**Drainage Letter
Rock Island Trail
Sand Creek to Constitution
Colorado Springs, Colorado**

Kiowa Project No. 16028
SWENT File: STM-REV24-____
EPC Project Number: CDR193

March 7, 2024

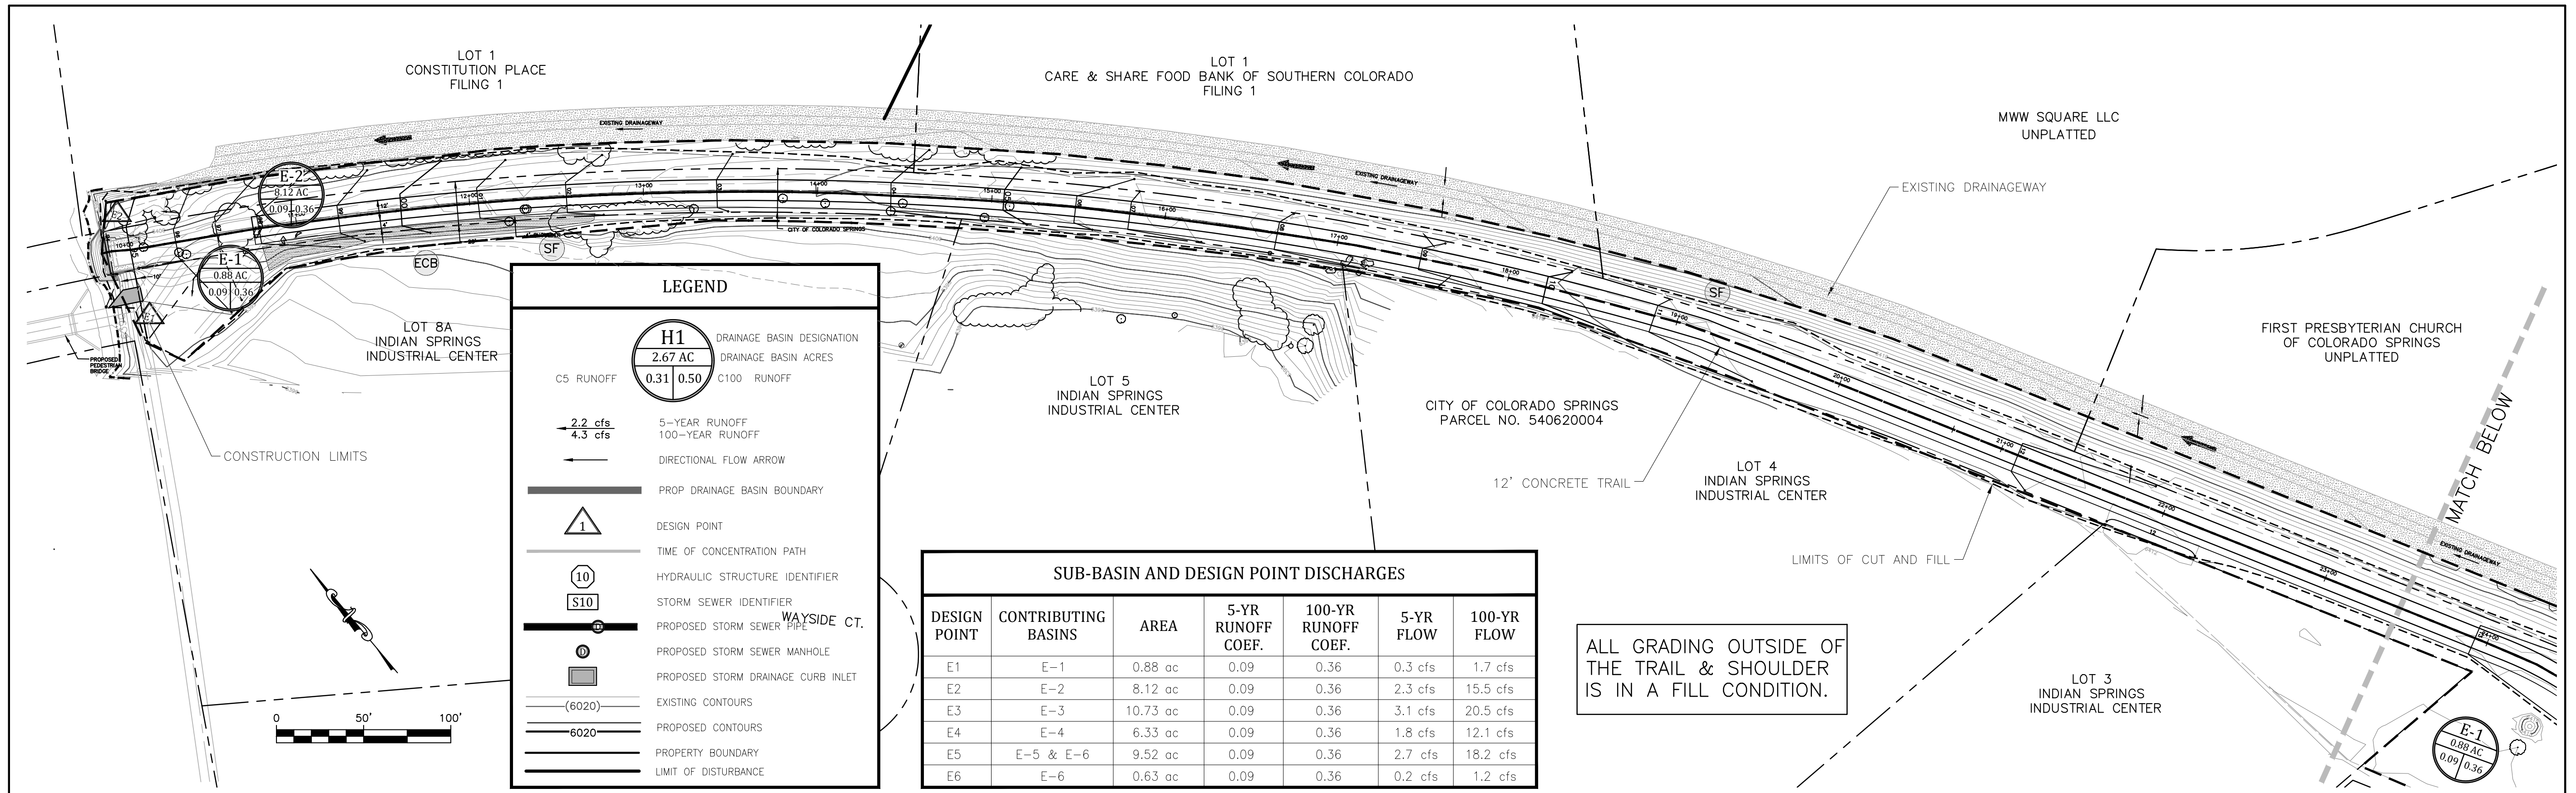
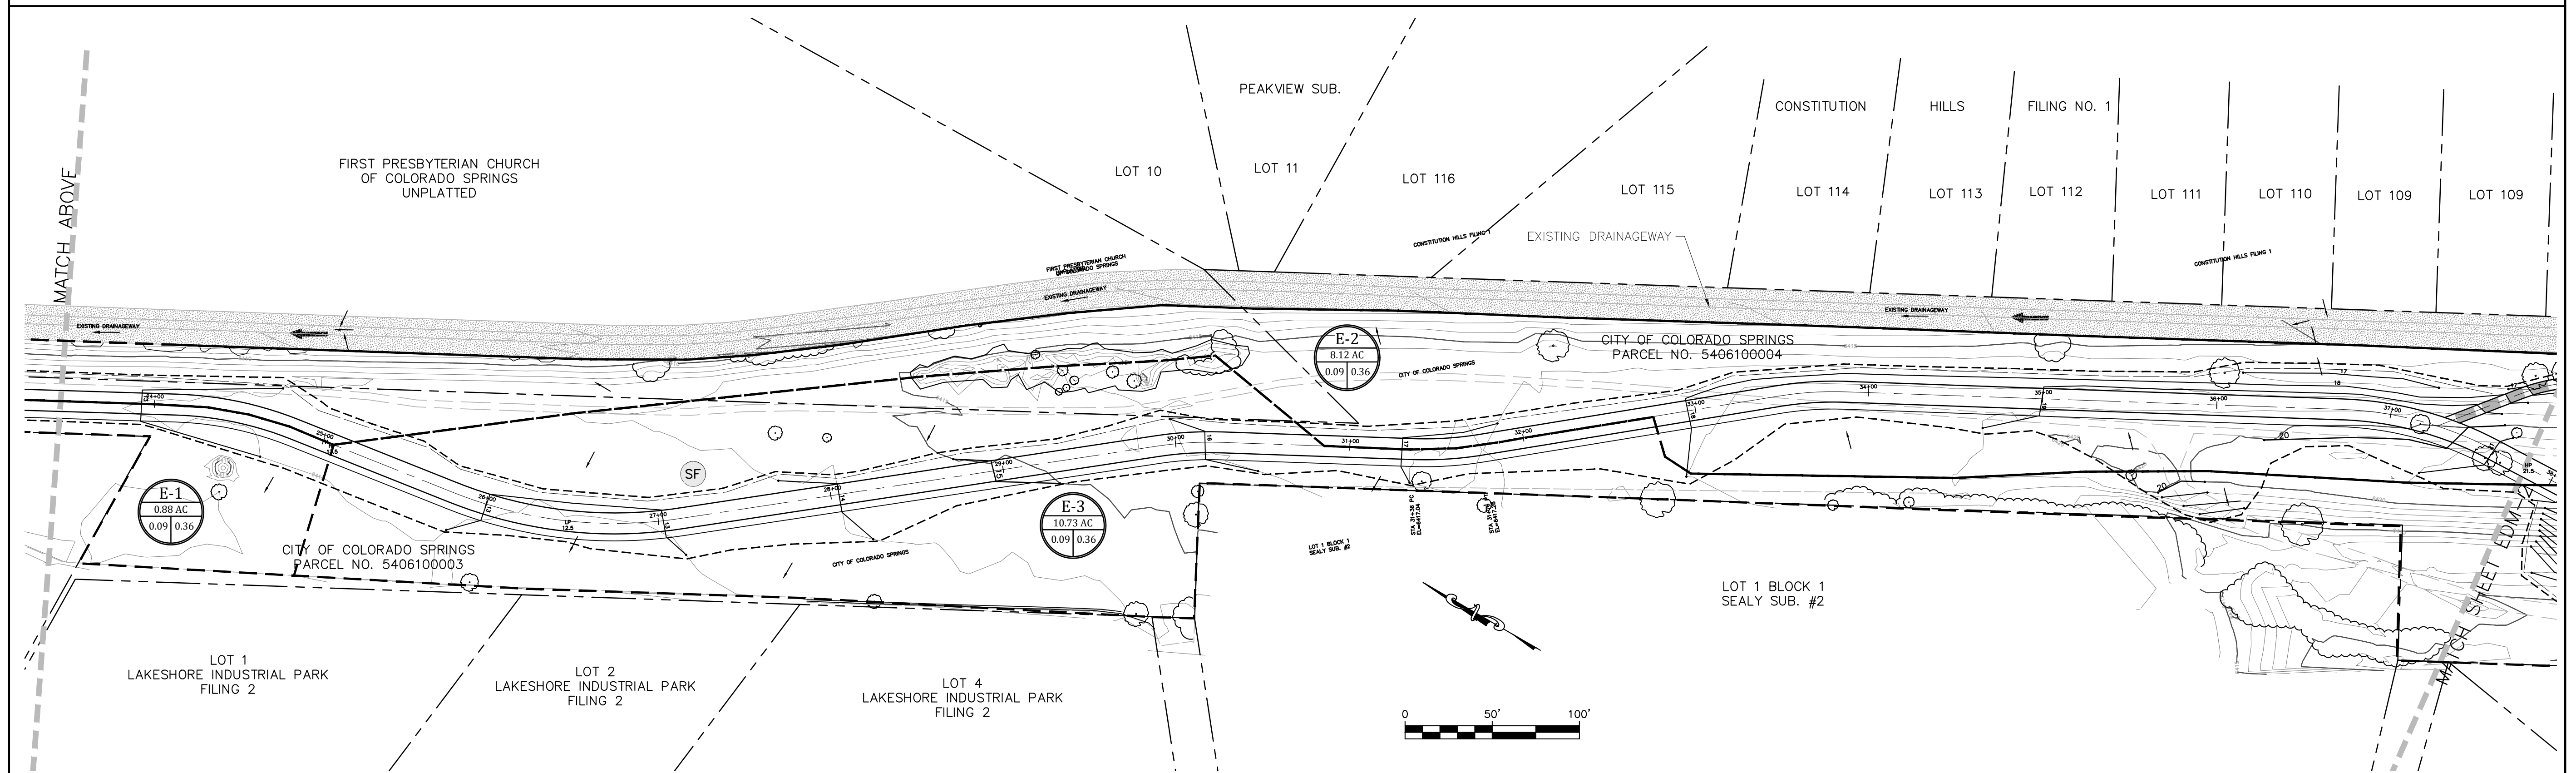
These maps provided are GEC
plans, not drainage maps.
Please provide existing and
proposed drainage maps.
